Staff Report & Recommendation — Historic Preservation Board

SUBJECT: File No. 7579, **6565 Collins Avenue – Sherry Frontenac Hotel.**

The applicant, S.F. Land, LLC, is requesting a Certificate of Appropriateness for the partial demolition and renovation of the existing building in order to increase the window opening size along the north, south and east elevations and to introduce balcony structures along the east elevation.

Image 1
Currently Proposed 1/12/16

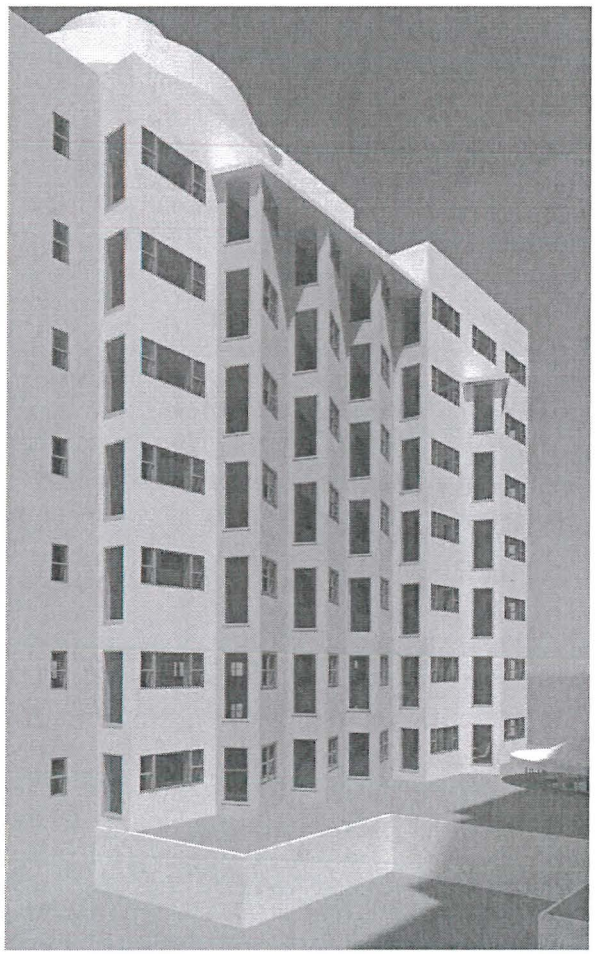
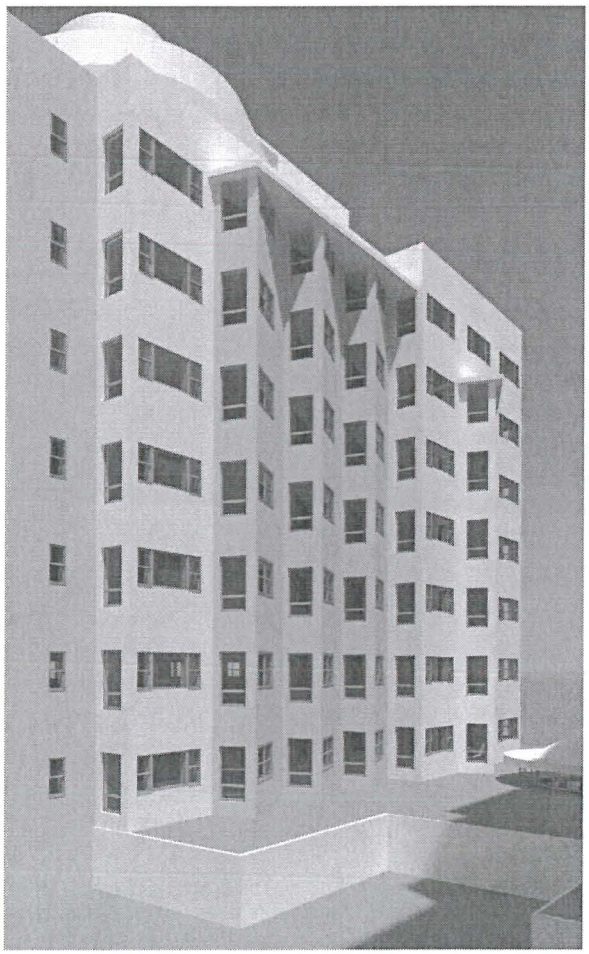
On December 8, 2105, the application was continued to the January 12, 2016 meeting at the request of the applicant. Since that time, revised plans have been submitted which propose to further enlarge the small ocean facing windows from a previously proposed height of 5'-10" to a height of 7'-4"; requiring the complete demolition of the masonry wall below the existing window.

The applicant is proposing to enlarge all existing windows openings along the east elevations to a height of 7'-4". These include the openings required to access the proposed balconies and the smaller ocean facing window openings. Staff has no objection to the enlargement of the openings required to access the new balconies. Staff does however, have a concern with regard to the smaller ocean facing windows as shown below in image 1. Staff believes the total demolition of the masonry wall below the existing openings will result in windows which are highly inconsistent and inappropriately proportioned to the existing Post War Modern architecture. Staff recommends that the increase in height of these openings be limited to the height of one panel of the existing single hung windows as previously proposed and illustrated below in Image 2.

a. The height of the small ocean facing windows shall not exceed 5'-10", consistent with Image 2 in the January 12, 2016 staff report, in a manner to be reviewed and approved by staff consistent with the Certificate of Appropriateness Criteria and/or the directions from the Board.

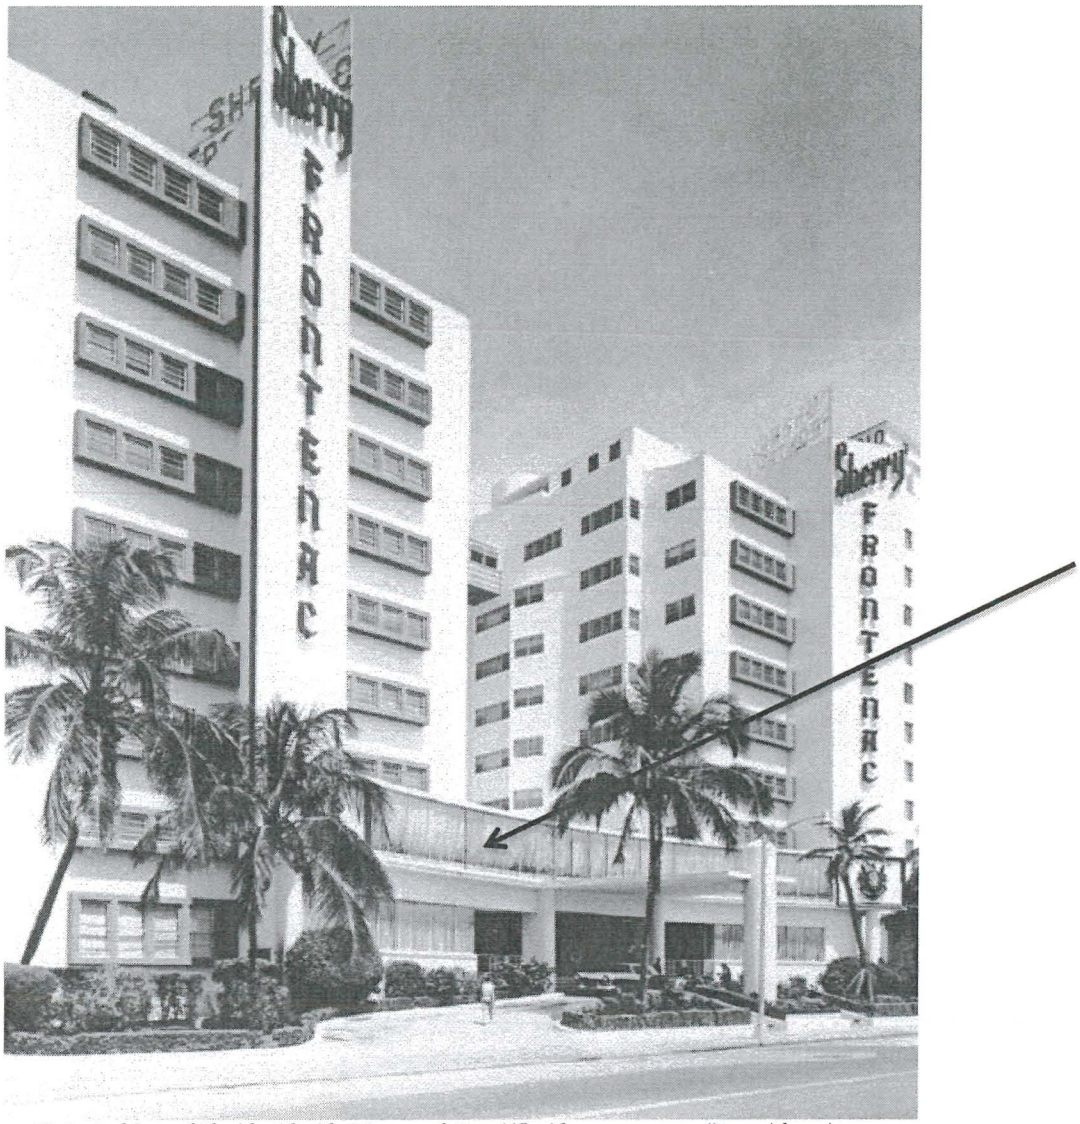
Finally, staff would note the original Post War Modern style structure is substantially intact including the decorative signage facing Collins Avenue. Although, staff laments the loss of the original skybridge which connected the top floors of the twin towers, demolished in 1980, staff recognizes the extreme engineering challenges that would be involved in the reconstruction of this element. Staff is however, extremely pleased that the elegantly curved glass wall located at the fourth level facing Collins Avenue is proposed to be reconstructed, as shown in the early 1950's photo below.

c. The original curved glass wall located at the fourth level facing Collins Avenue shall be recreated to the greatest extent possible in accordance with available historical documentation, in a manner to be reviewed and approved by staff consistent with the Certificate of Appropriateness Criteria and/or the directions from the Board.
